Access Compliance Report

Public Rights-of-Way

Intersection ID: 5523	Main Street: MALLARD_PARK_DR	Cross Street: PINE_BRANCH_CT	Location: S
ADA ID: 214F08DD1AC3	Ramp Type: Perp	Initial Pass/Fail: Fail	Overall Compliance: No
		Severity Score: 35

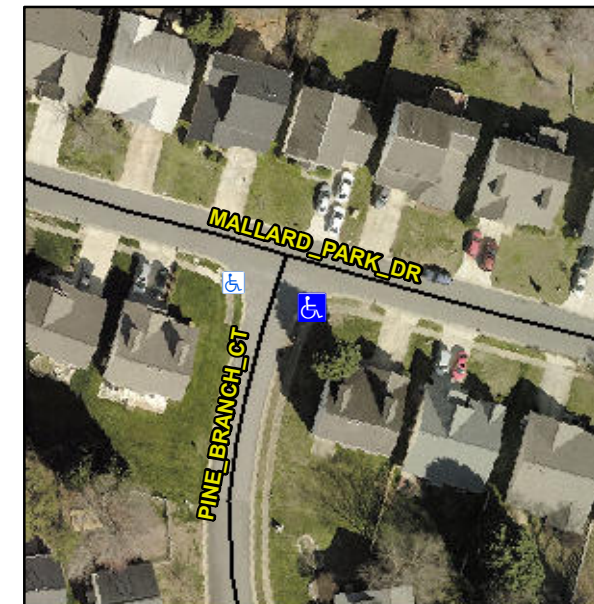
Not Found, R304.5.1

Compliance	Description	Data	Compliance	Description	Data
N/A	Ramp Length (in)	97.0	Yes	Ramp Slope (%)	7.7
No	Ramp Width (in)	29.0	Yes	Ramp XSlope (%)	0.9
N/A	Flare Type LT	N/A	N/A	Flare Type RT	N/A
N/A	Flare Slope LT (%)	N/A	N/A	Flare Slope RT (%)	N/A
N/A	Flare Traversable LT?	N/A	N/A	Flare Traversable RT?	N/A
N/A	Landing Length (in)	N/A	N/A	DWS Provided?	N/A
N/A	Landing Width (in)	N/A	N/A	DWS Contrast?	N/A
N/A	Landing Slope (%)	N/A	N/A	DWS Length (in)	N/A
N/A	Landing X Slope (%)	N/A	N/A	DWS Full Width?	N/A
N/A	Landing Curb? (Y/N)	N/A	N/A	DWS Offset (in)	N/A
N/A	Shared Landing?	N/A			
N/A	Gutter Ponding?	N/A	N/A	Gutter Slope (%)	N/A
N/A	Gutter Lip Ht (in)	N/A	N/A	Gutter X Slope (%)	N/A
N/A	Painted X Walk1?	No	N/A	Painted X Walk2?	N/A
	X Walk 1 Direction	To NW		X Walk 2 Direction	N/A
N/A	X Walk 1 Width (in)	N/A	N/A	X Walk 2 Width (in)	N/A
	X Walk 1 Slope (%)	5.4		X Walk 2 Slope (%)	N/A
	X Walk 1 X Slope (%)	0.5		X Walk 2 X Slope (%)	N/A

Remove & Replace Entire Ramp.
